**CITY OF RICHLAND DEVELOPMENT SERVICES DIVISION  
STAFF REPORT TO THE HEARING EXAMINER**

PROPOSAL NAME: South Orchard – Major Plat Amendment

FILE NO.: SA2023-102

PROJECT TYPE: Type III Preliminary Plat Major Amendment

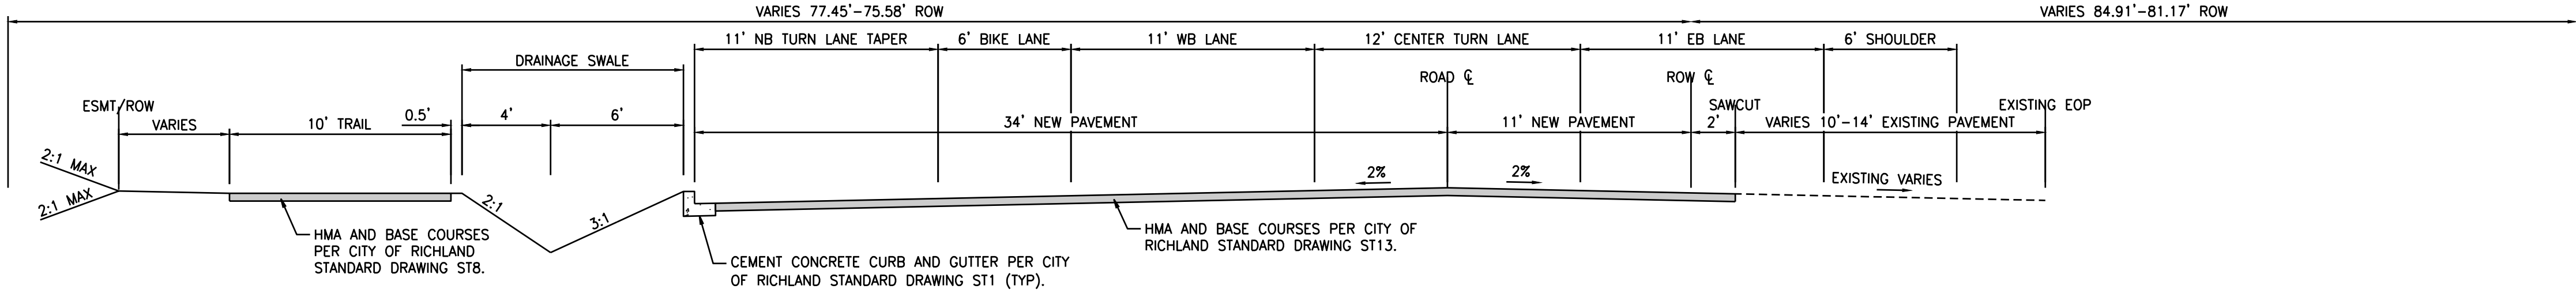
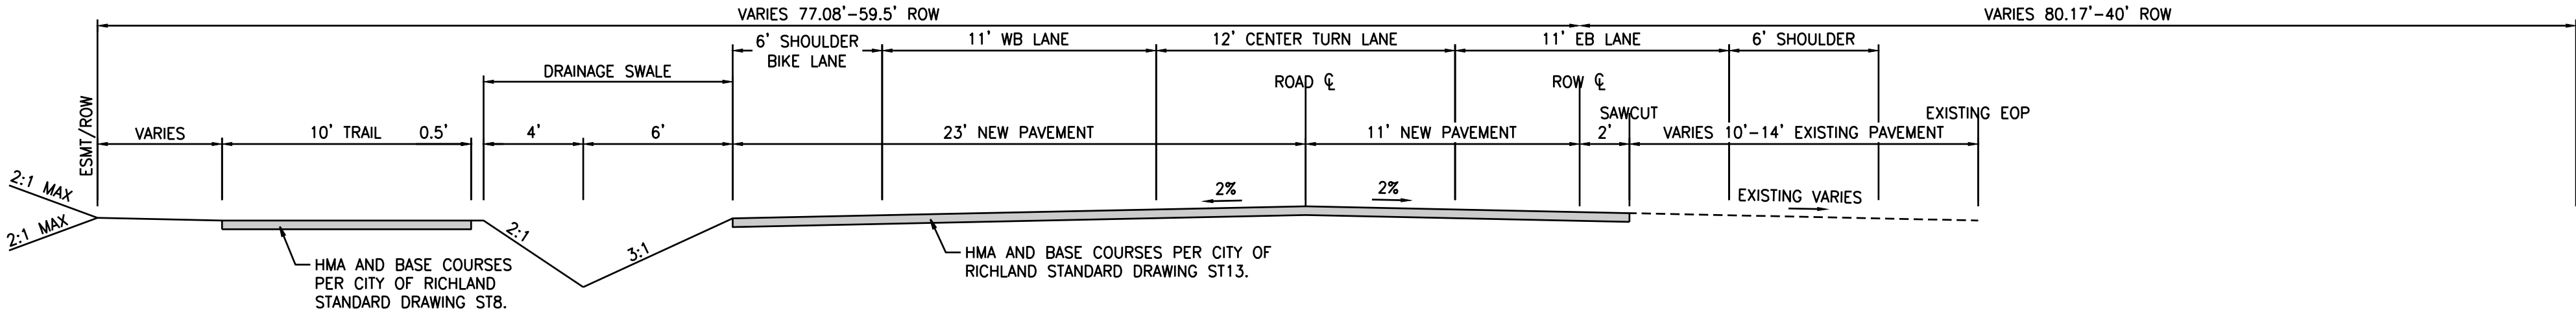
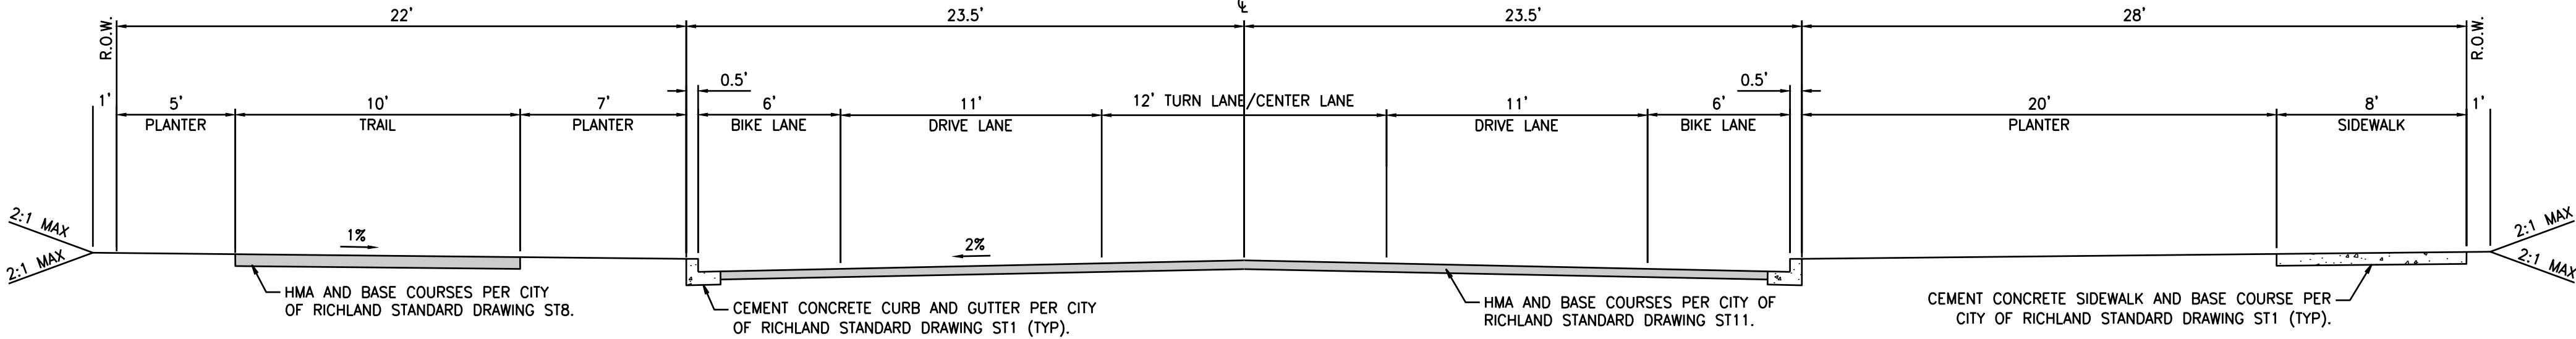
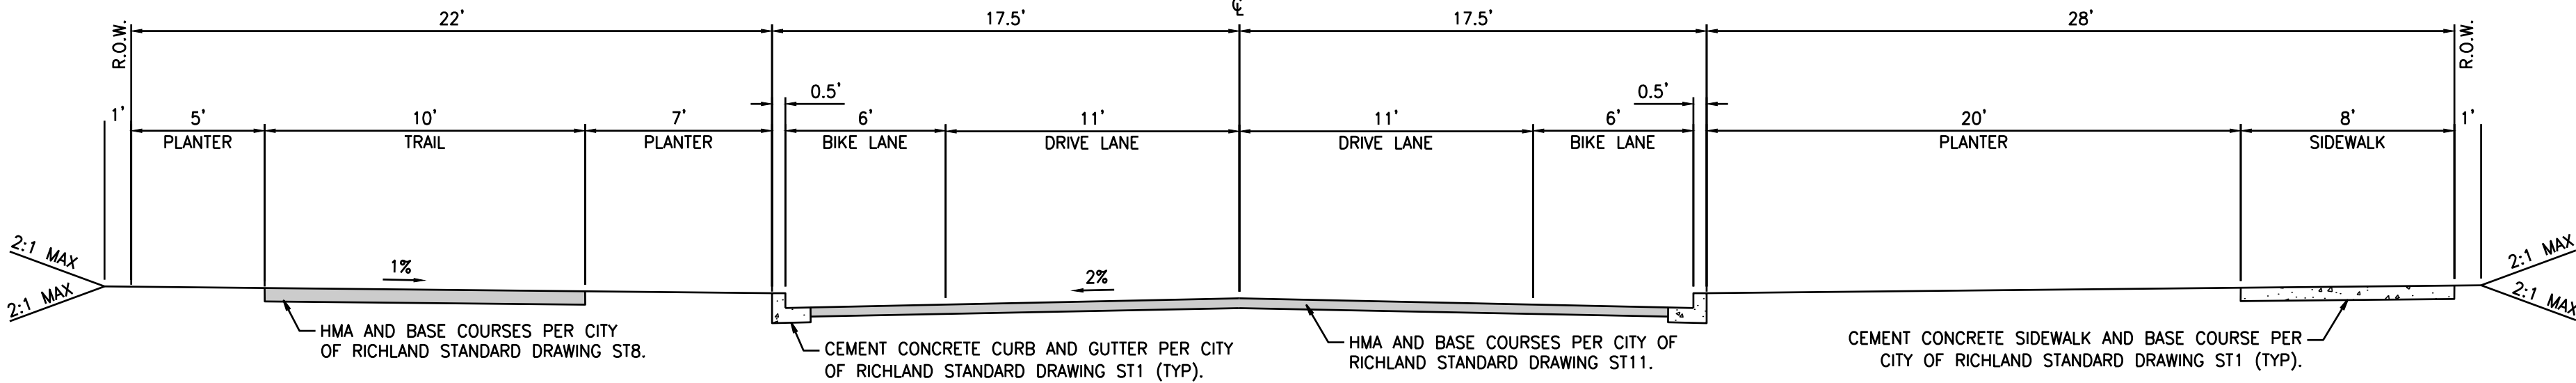
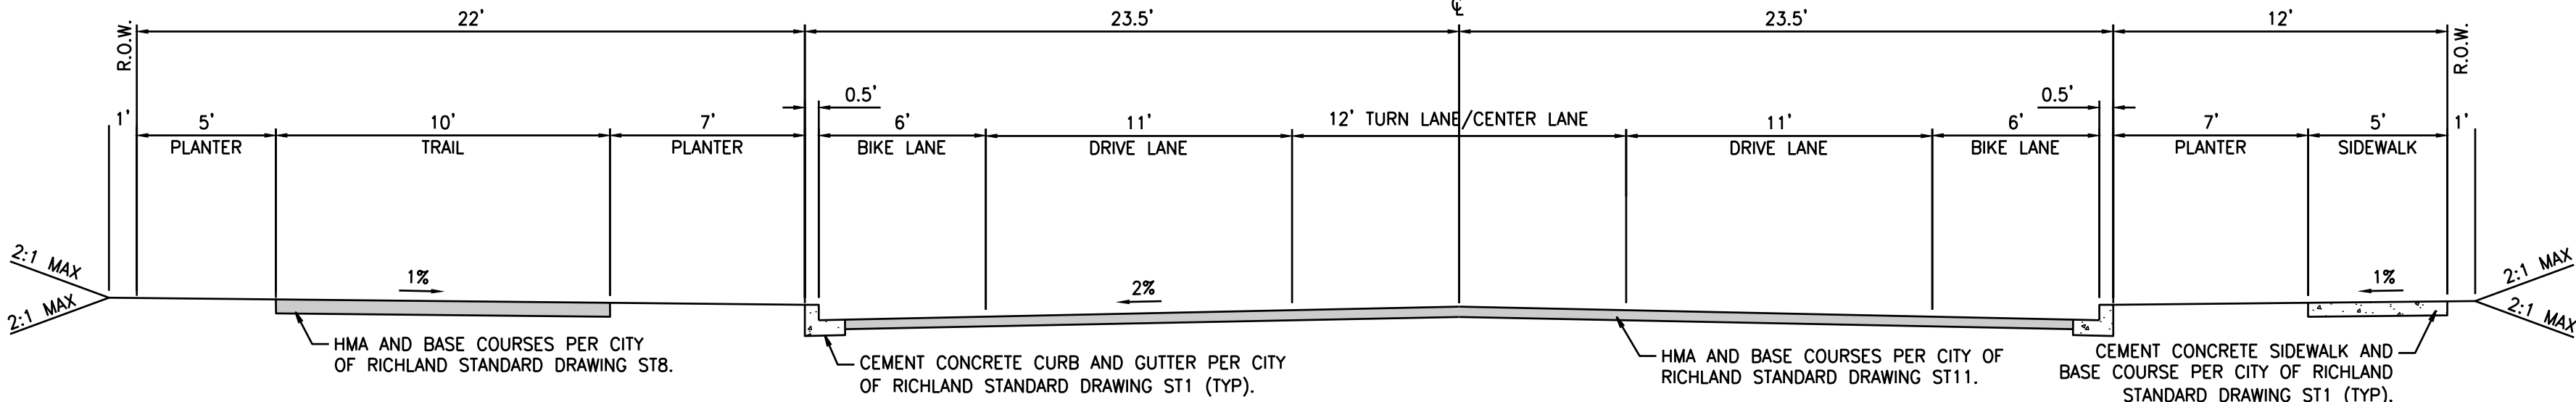
- 24. Sheet C002 identifies a road section with a median, however it is not clearly identified where that road section is intended to be within the pre-plat. Medians shall not interfere with left-turning movements at intersections. The developer shall obtain approval from the City’s Traffic Engineer for all median designs.

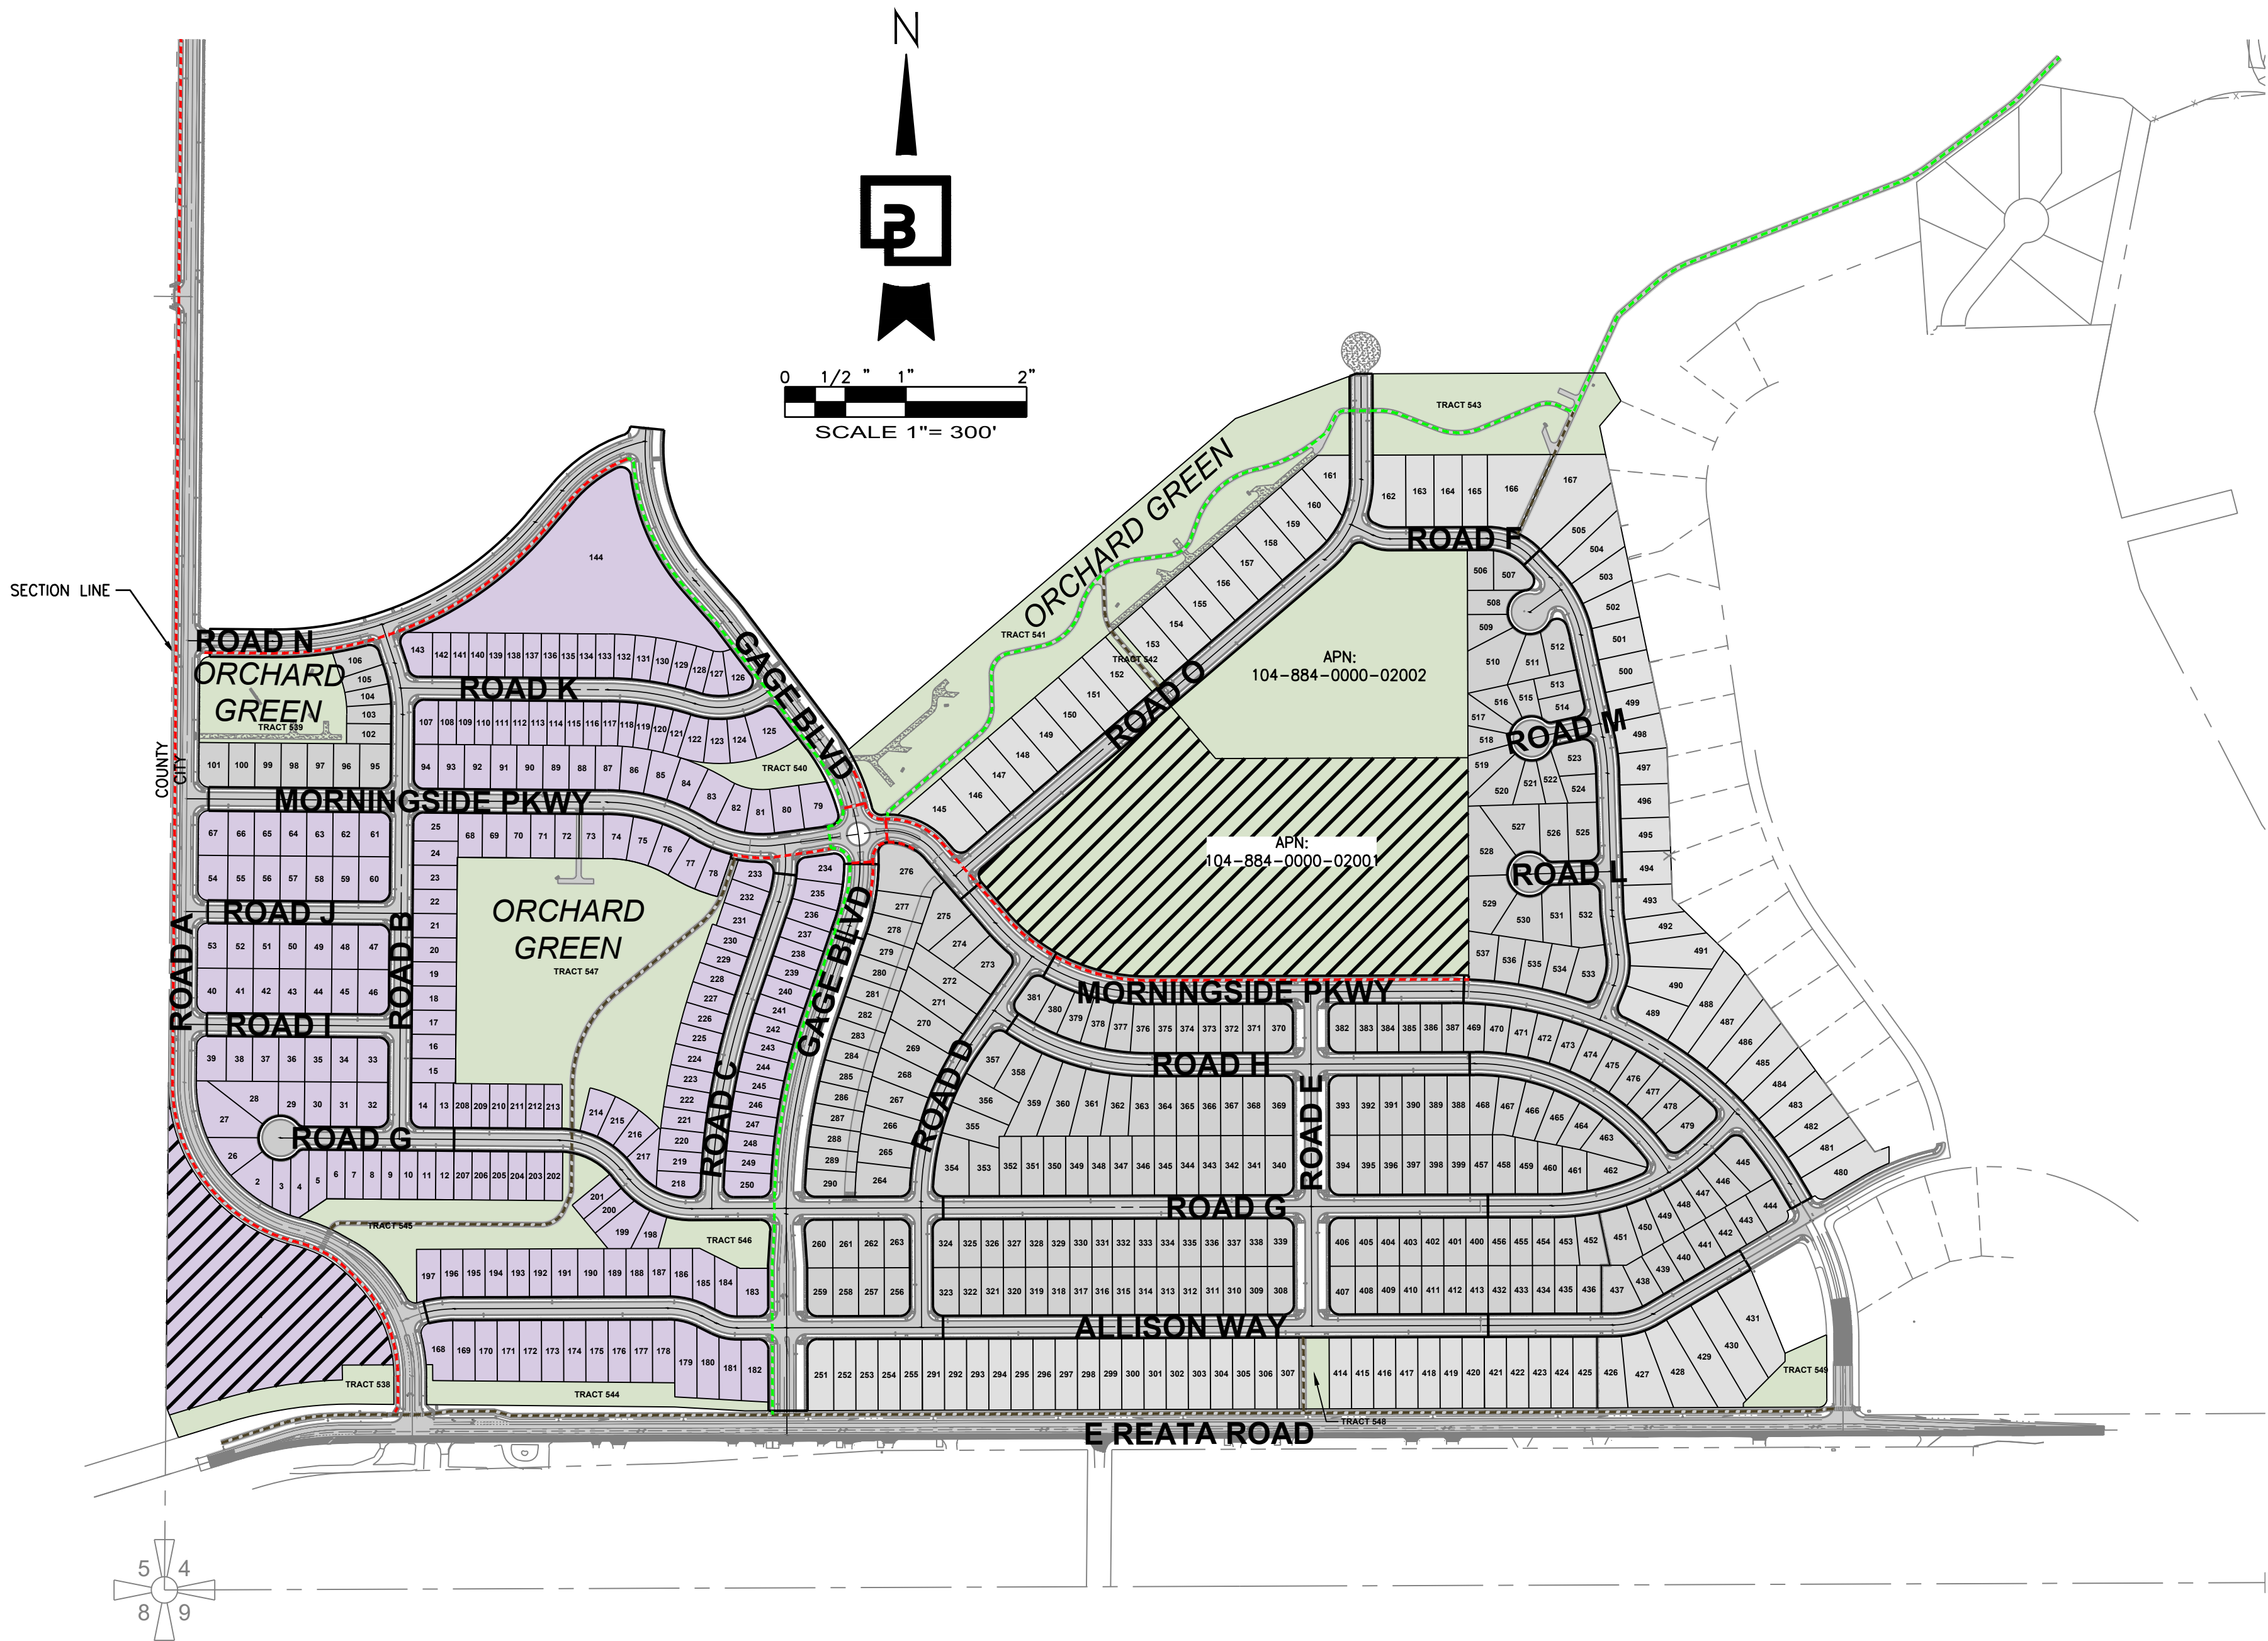
3. Any future storm drainage tracts will be dedicated to the city for ownership. The “Tract Note” on sheet C001 of the pre-plat should be amended to include this.

77. Note #3, as shown on sheet C001 of Exhibit 2, is not valid and shall not appear on any subsequent final plat(s). All lots shall be designed to meet setback requirements of the applicable BMS zoning district(s).

17.D

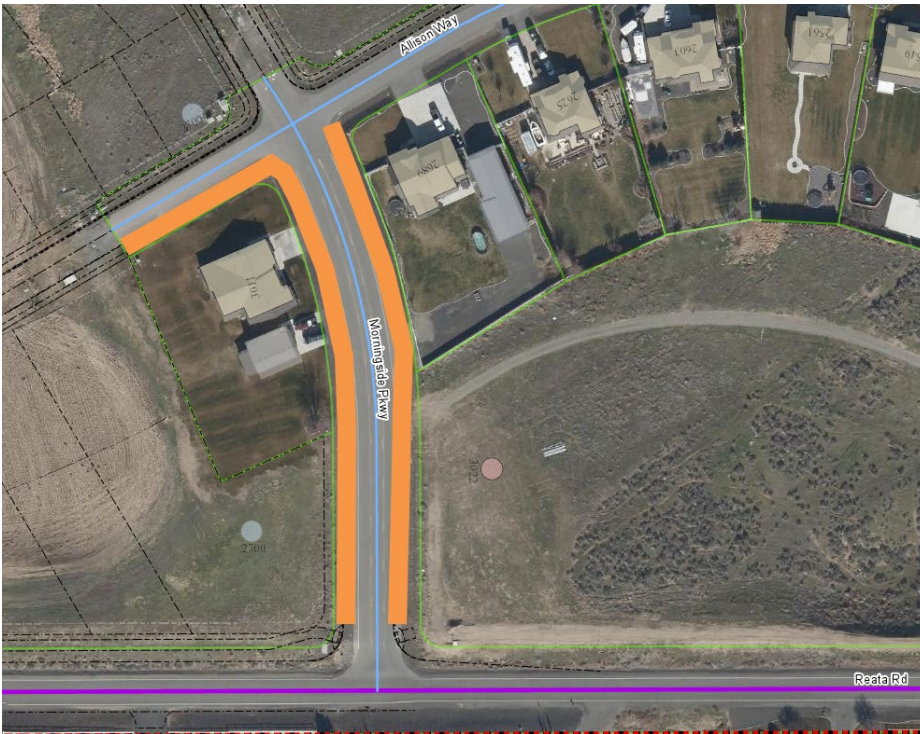
- D. The Morningside Parkway/Reata Road intersection improvements shall include a westbound right turn lane from Reata onto Morningside, an eastbound left turn lane from Reata onto Morningside, and a southbound right turn lane from Morningside onto Reata. These intersection improvements shall be completed along with the phase that completes the Morningside Parkway corridor.**

The above condition we agree with, we are fortunate that Geoff is within control of the property that would dedicate portions of land to us to make this happen. This condition also will provide a degree of intersection safety to offset the additional 64 lots and the trips they will generate. **This is good news.**
